COMPANY: Electronics Tomorrow Ltd.				
MODEL: 7966				
PCB VER: V1.1	TITLE:	SCH	DOC VER: 01	
DRN. /DATE: ZB 16/3/04		DWG NO: 7966E11231		
CHK. /DATE: 2004/3/16		IC: RX3310A		
APP. /DATE: 2004/3/16		LCO:		
☒ TO FILE		☒ REL		SHEET OF: EF005

7966-07-1

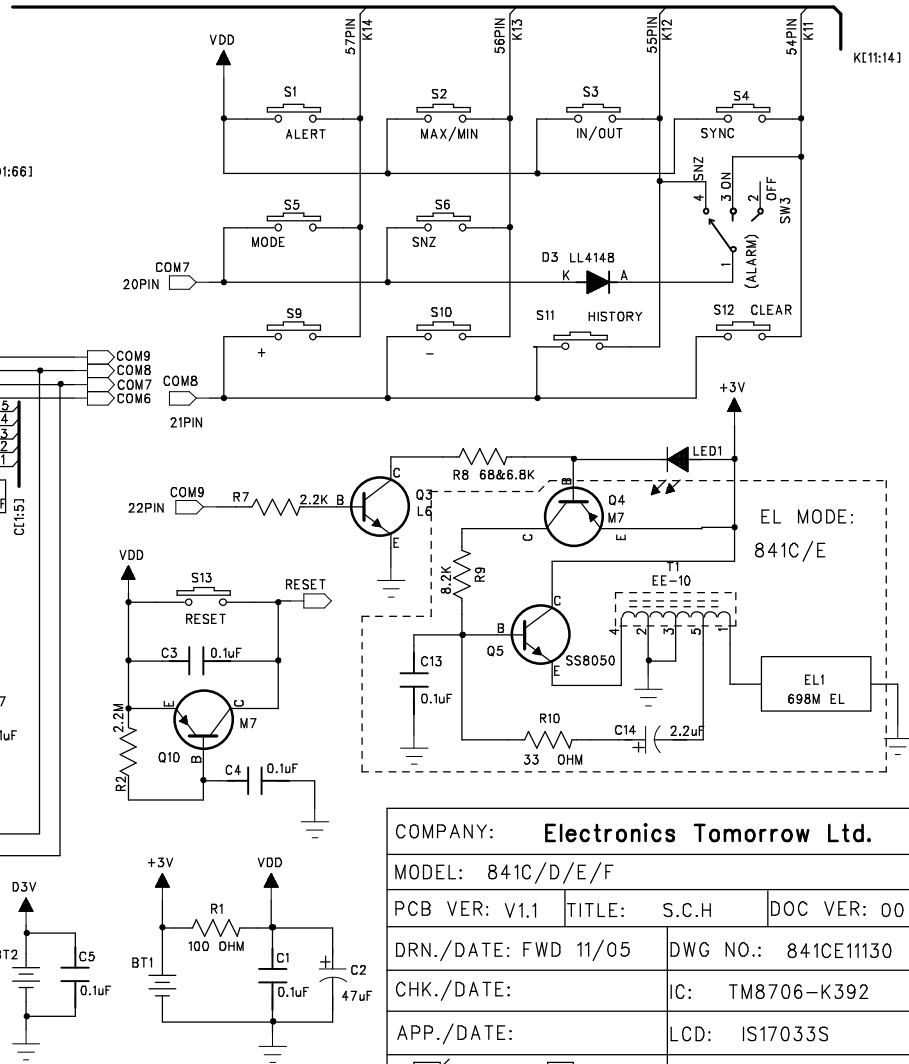
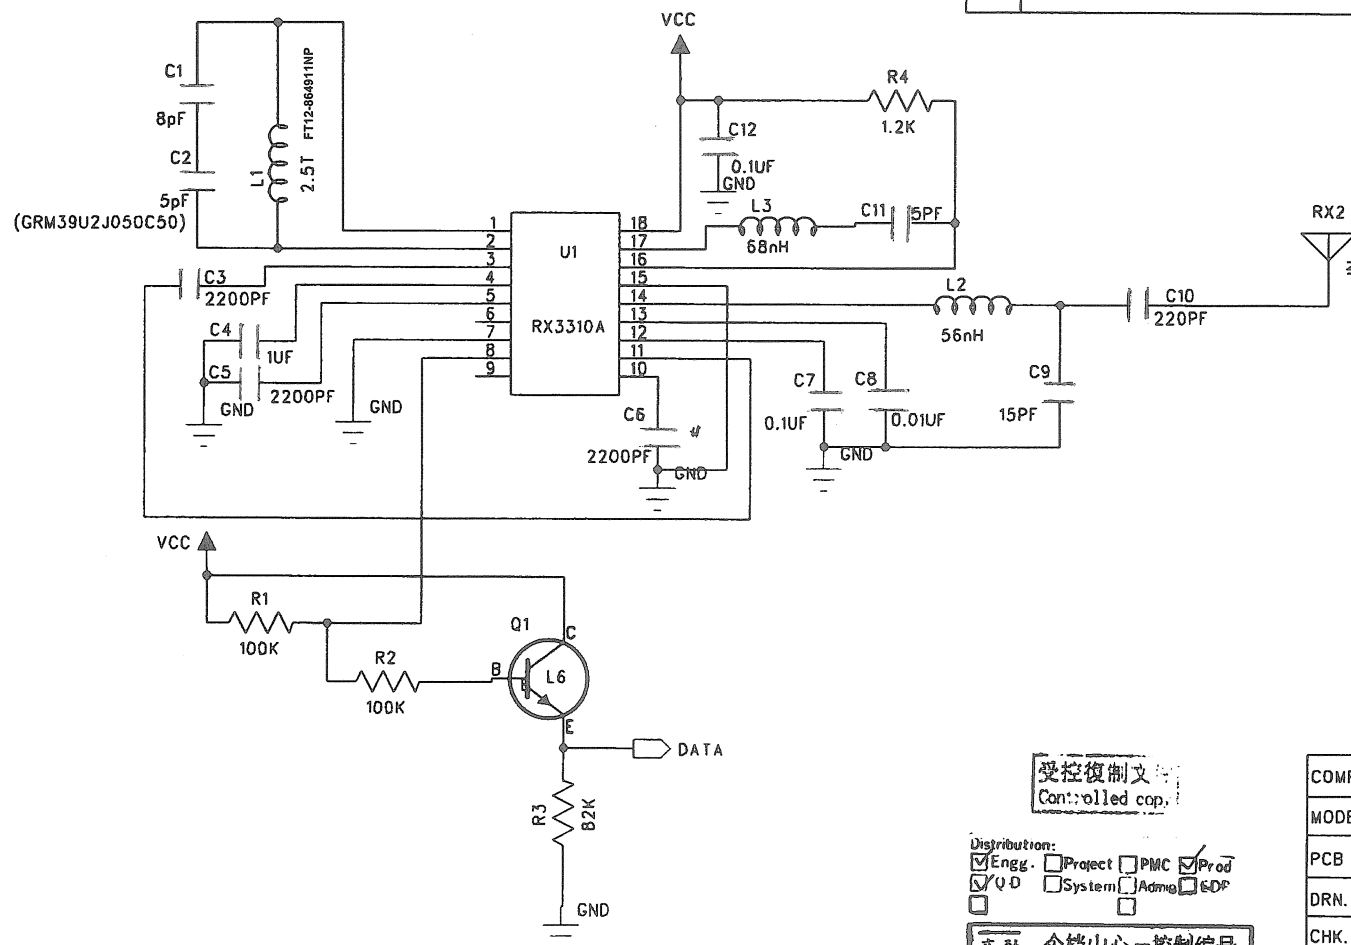
The substrate of chip should be connected GND

REV.	MODIFICATION	DATE:	CHK:	APP:
1	change hole size	19/8/03		
2	change c1 to 6pf	16/3/04
